DEVIATION REQUEST AND DECISION FORM

Project Name : Eagleview Subdivision
Schedule No.(s) : 5226000001), 5226000001)
Legal Description : N2NW4 EX WLY 620.0 FT SEC 26-12-65,S2NW4 EX WLY 620.0 FT SEC 26-12-65

A deviation from the standards of or in Sections **2.3.7.D.2** of the Engineering Criteria Manual (ECM) is requested.

Exhibit 1

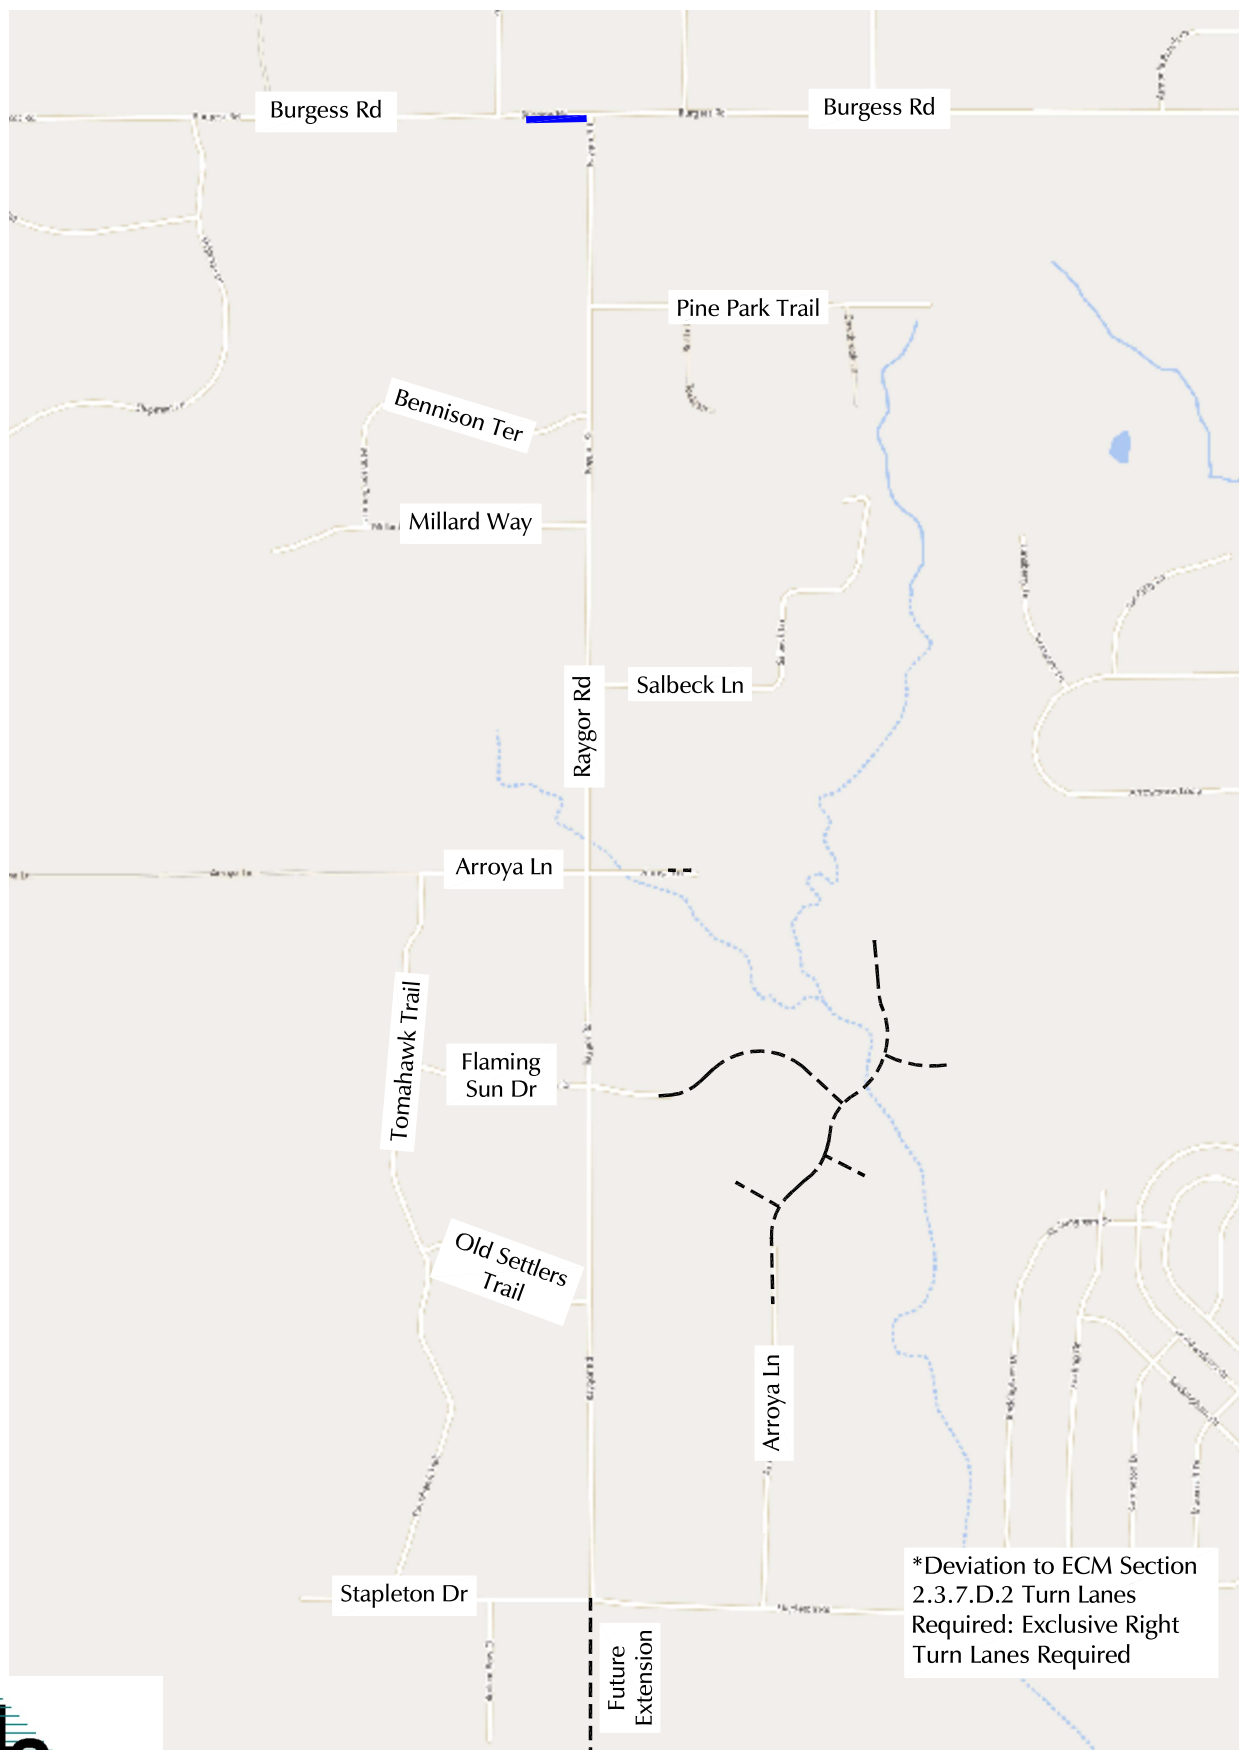
- Based on the projected short-term eastbound right-turn volume at the intersection of Burgess/Raygor, the 50 vph threshold requiring a right-turn lane would be exceeded.
- Significant constraints to constructing an eastbound right turn exist on the southwest corner of the Burgess/Raygor intersection. There is a utility pole on the corner and numerous utility boxes on the corner as well. Also, along the south side of Burgess Road west Raygor there are significant slopes in this area. There is limited ROW along Burgess Road.

- Once Raygor is connected to the south, the right turn volumes are projected to fall below the 50 vph threshold.
- The alternative would be to not construct the deceleration lane, rather add asphalt and striping to improve the side street (Raygor) at the intersection to the extent possible. This would include patching and expanding the asphalt on the corner radii as much as possible and extend/taper the new pavement a short distance south of the intersection itself.

- Add white edge striping along the corner radii, add a stop bar on the northbound approach and a double yellow centerline stripe for about 50 feet to the south. The centerline stripe be positioned to maximize the width of the "departure lane" (the southbound lane) on Raygor.

- Add a "Do Not Pass" sign for eastbound traffic on the eastbound approach to the intersection.

Section of Burgess for which Deviation #1 is requested

Deviation No. 1*
